REGIONAL REVIEW FINDING

ATLANTA REGIONAL COMMISSION

Name of Proposal: **Johns Creek Mixed Use Development DRI 3742**
Submitting Local Government: City of Johns Creek
Date Opened: September 28, 2022 **Date Closed:** October 20, 2022

Description: Project Description: A DRI review of a proposal to create a mixed-use development with 200,000 SF of retail, 800 multi-family units, 150 townhomes, 110,000 SF of existing office space and a civic facility on a site at the SE corner of the intersection of Johns Creek Parkway and McGinnis Ferry Road in the City of Johns Creek in Fulton County.

TITLE
DRI SITE PLAN

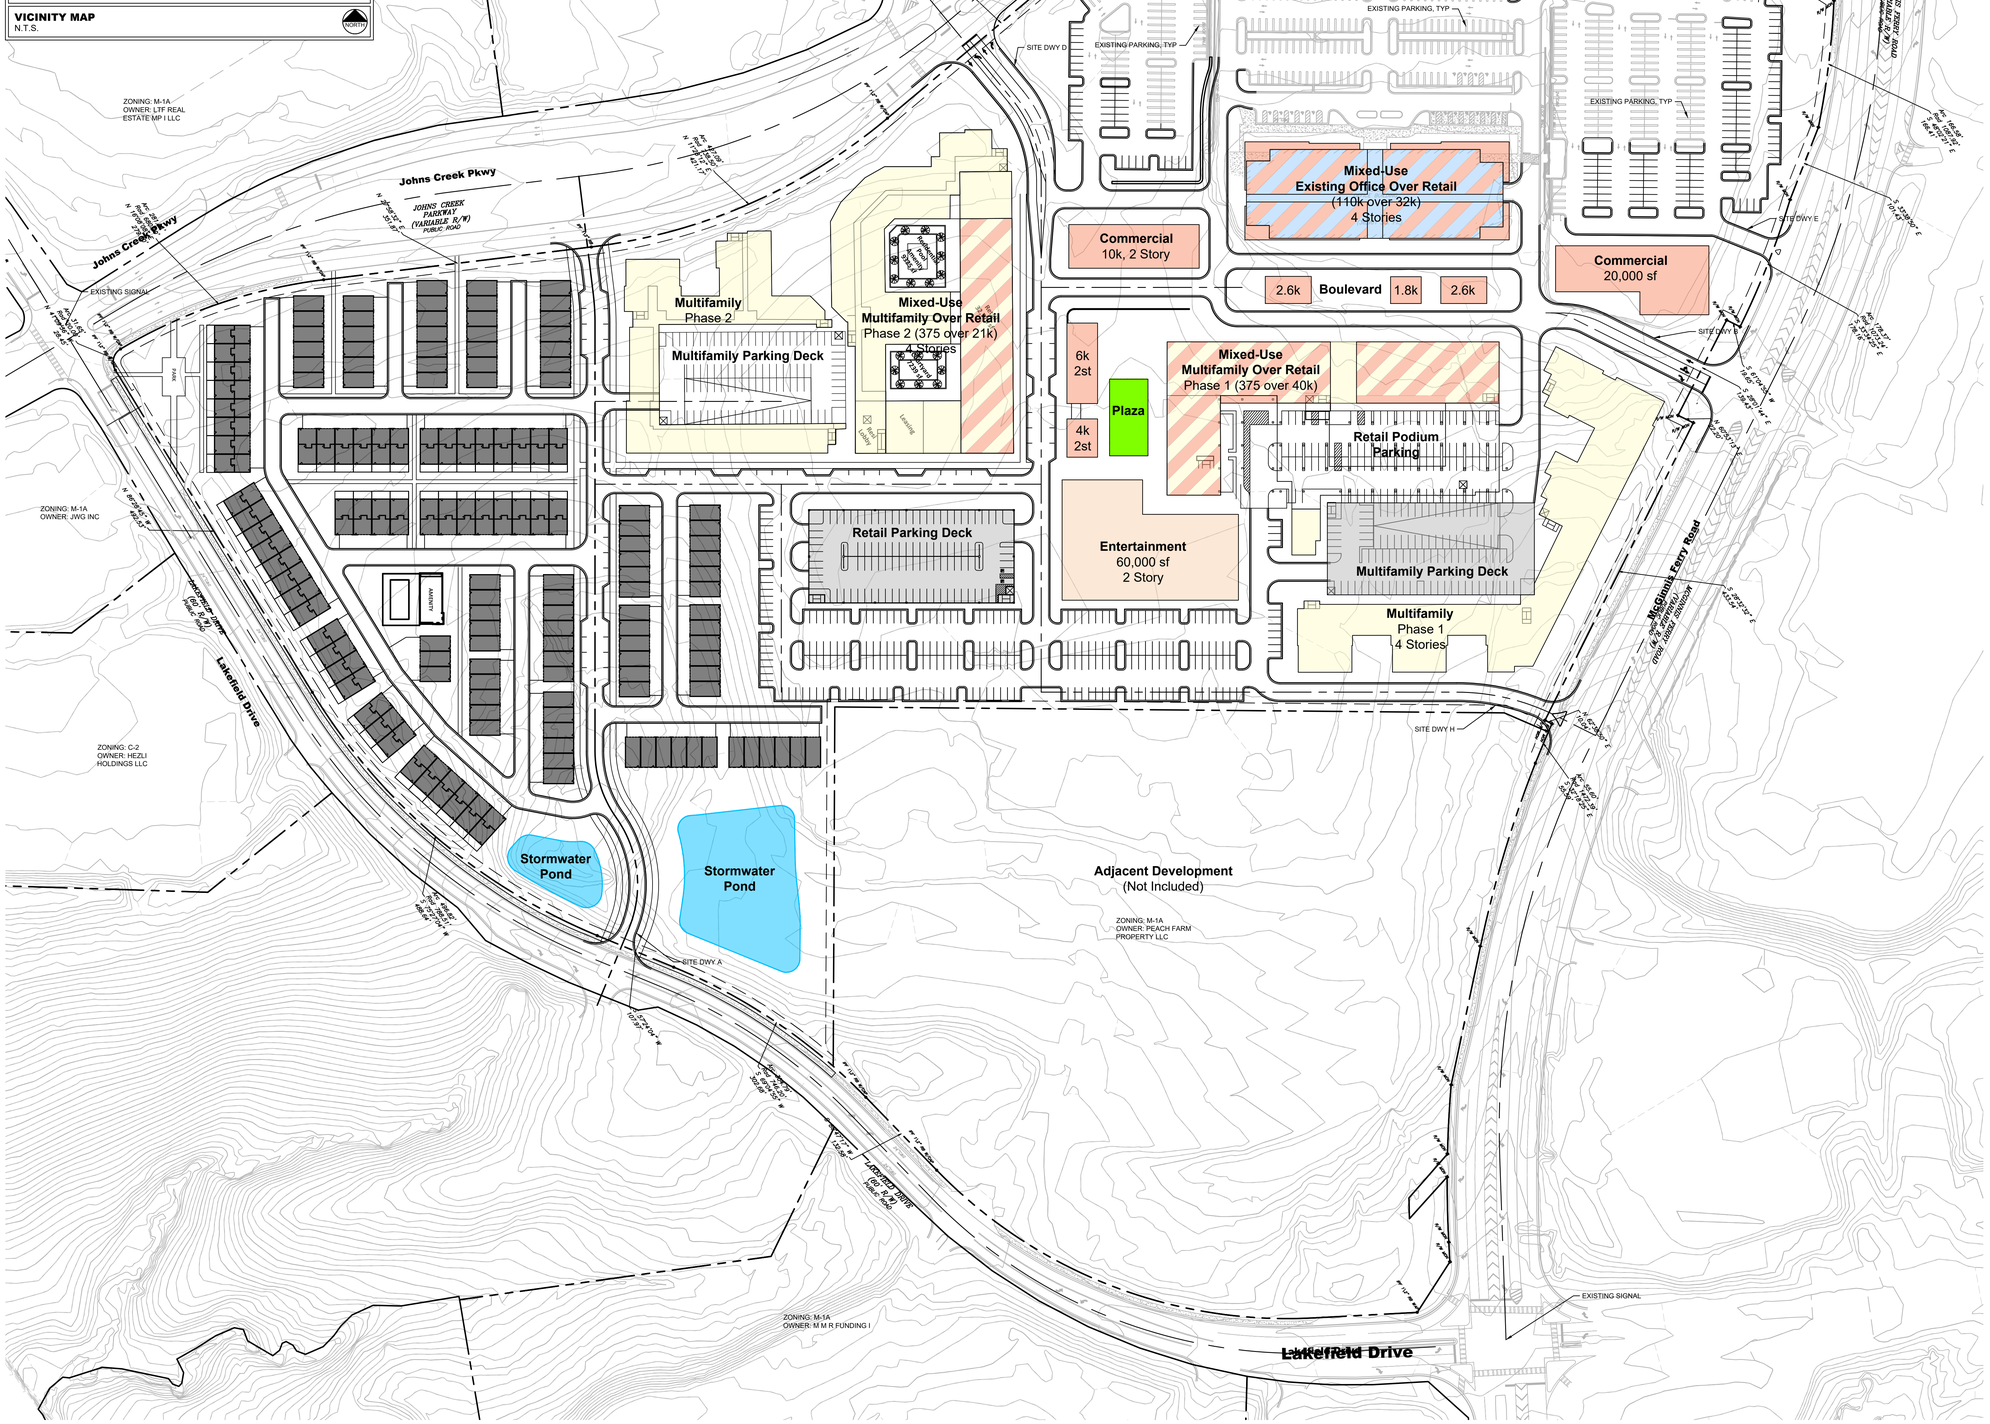
The creation of the central Boulevard flanked by mixed-use buildings with active street levels as well as the commercial and multi-family buildings fronting McGinnis Ferry are strongly supportive of regional placemaking policies.

A total of 2,706 parking spaces in structured decks and surface lots are proposed which is substantially more than the minimum required number of 2,260 spaces; alternative parking strategies that could limit the total parking spaces would be supportive of regional transportation policies.

No bicycle parking spaces or EV charging spaces appear to be proposed; inclusion of a generous amount of both would be strongly supportive of regional EV infrastructure and multi-modal transportation policies.

The creation of the central Boulevard flanked by mixed-use buildings with active street levels as well as the commercial and multi-family buildings fronting McGinnis Ferry are strongly supportive of regional placemaking policies. The project's urban edge along Johns Creek Parkway is weaker with only surface parking from McGinnis Ferry Road to driveway D. This edge, and the functional connection of the overall project to the civic area the west, could be substantially strengthened by adding some park compatible uses in buildings along the Parkway, in particular flanking driveways D and F.

Strengthening the pedestrian connections between the core of the project and the central north-south Johns Creek Parkway corridor, which will function as a linear park with a multi-use trail, would enhance trail connectivity and functionality.

No bicycle parking spaces or EV charging spaces appear to be proposed; inclusion of a generous amount of both would be strongly supportive of regional EV infrastructure and multi-modal transportation policies. Care should be taken to ensure that the development promotes an interconnected, functional, clearly marked and comfortable pedestrian experience on all streets, paths, entrances, and parking areas. To the maximum extent possible, new driveways and intersection corners where pedestrians will cross should be constructed with minimal curb radii to reduce speeds of turning vehicles and decrease crossing distances for pedestrians.

The re-use of the existing large surface parking areas is highly supportive of regional stormwater and redevelopment goals. Ensuring maximum tree canopy in the remaining surface parking areas and throughout the site would further advance regional goals regarding heat island effect mitigation.
The project can further support The Atlanta Region's Plan in general by incorporating other aspects of regional policy, including green infrastructure and/or low-impact design, e.g., pervious pavers, rain gardens, vegetated swales, etc., in parking areas and site driveways, and as part of any improvements to site frontages.
